Univent Replacement at Farley Elementary School
Univent Replacement at Willow Grove Elementary School
MSA File No. 42052

SED No. 50-02-01-06-0-003-011
SED No. 50-02-01-06-0-030-016

Re: ADDENDUM NO. 1

© COPYRIGHT, MICHAEL SHILALE ARCHITECTS, ALL RIGHTS RESERVED.
Drawing Title
**HVAC INSTALLATION
FIRST FLOOR PLAN - 1**
Drawing No.
FES-M-101

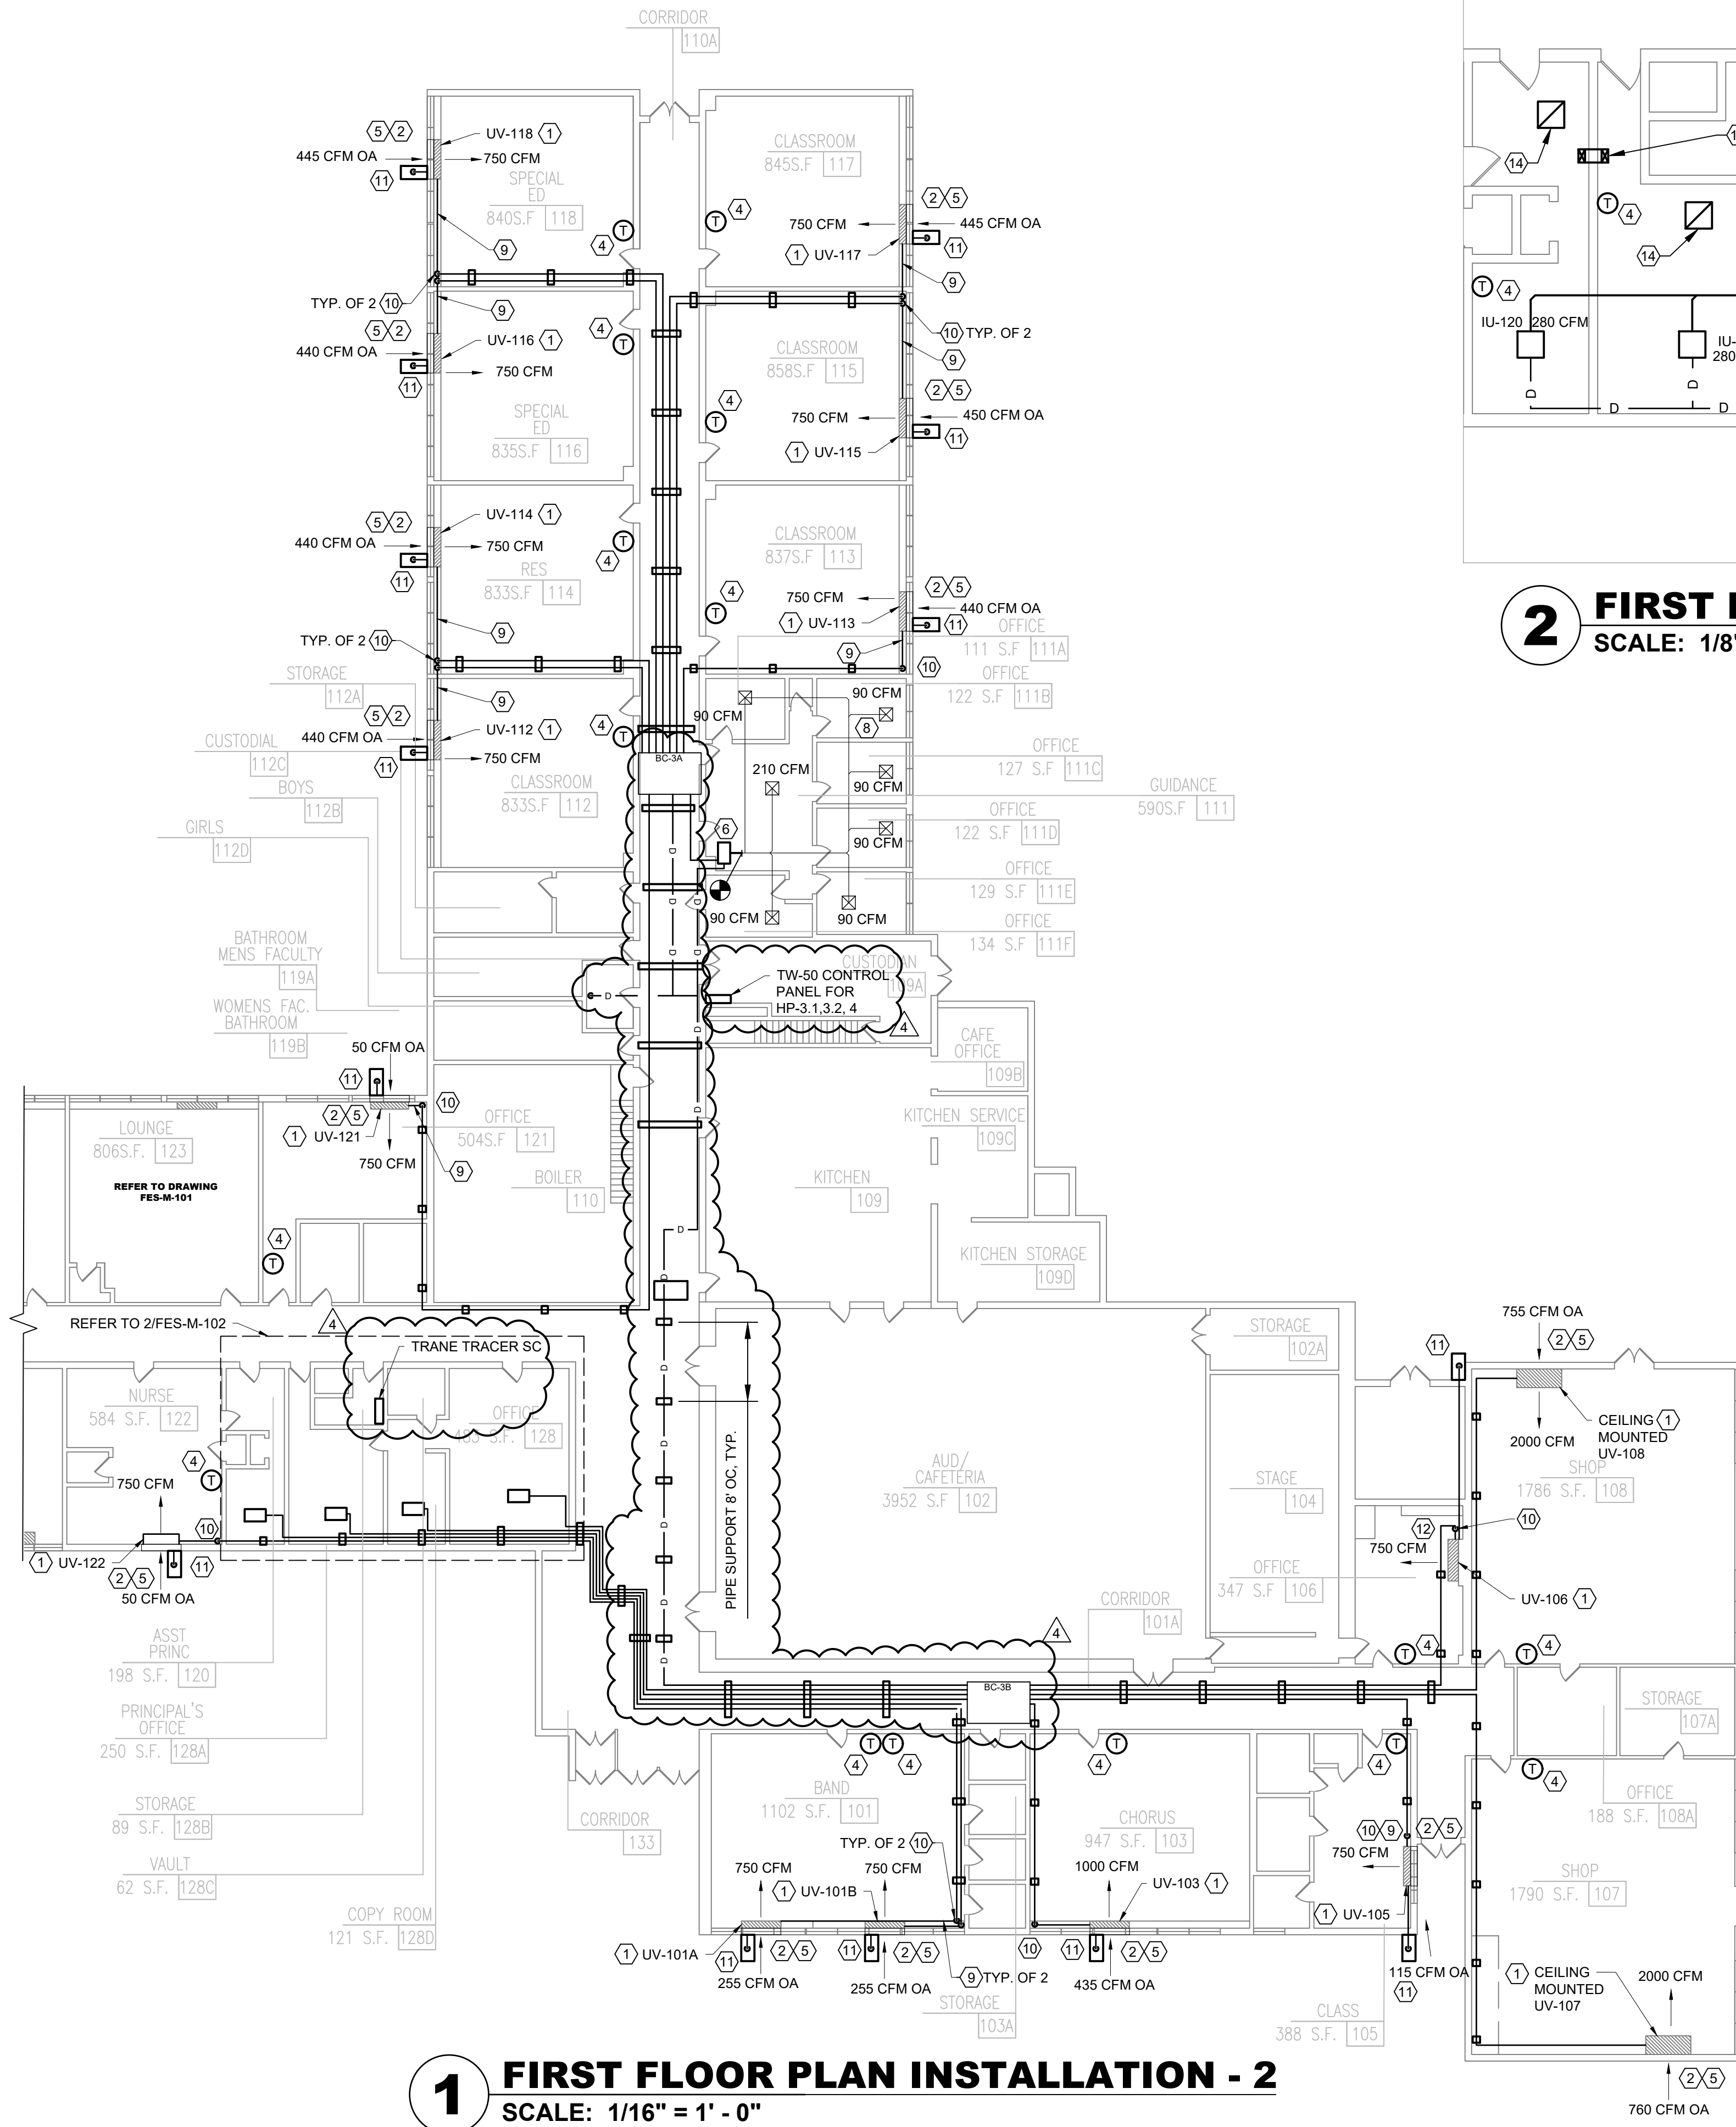
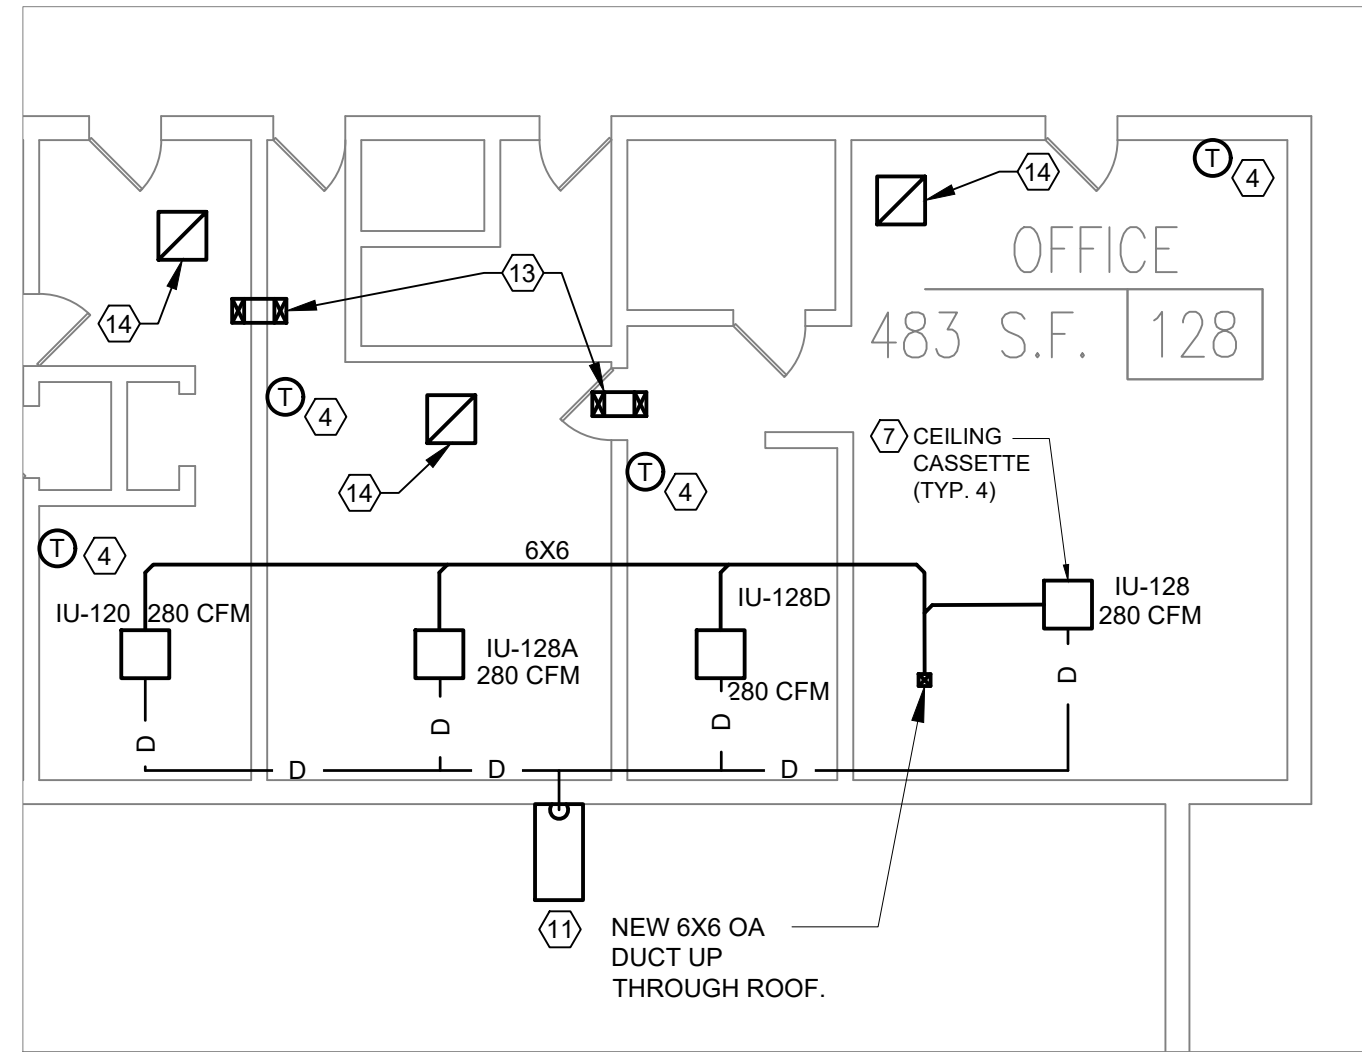
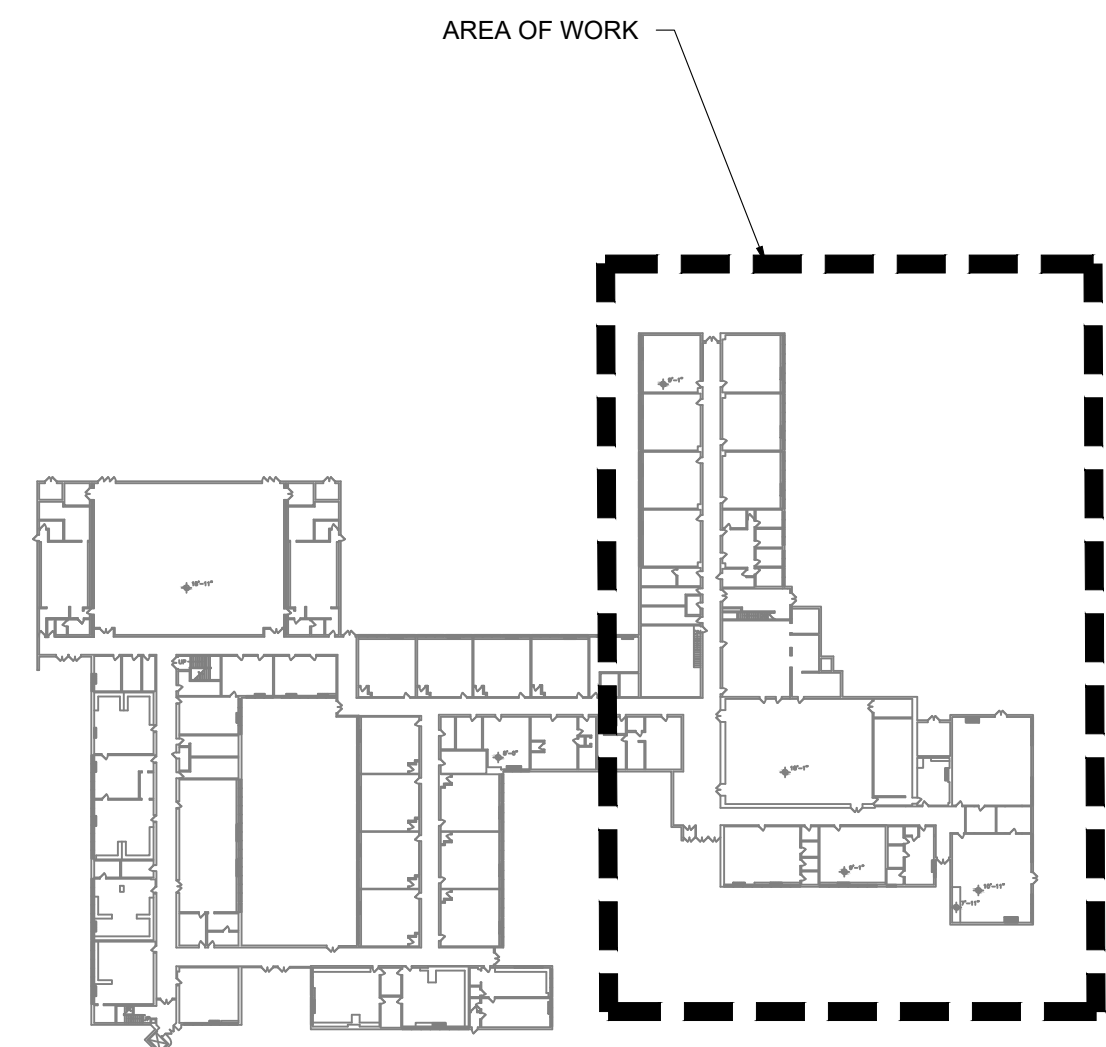
- 18) Drawing FES-M-101 has been revised dated, 11-09-23, see attached. Revisions include updates to the drain piping and the refrigerant piping.
- 19) Drawing FES-M-102 has been revised dated, 11-09-23, see attached. Revisions include updates to the piping support.
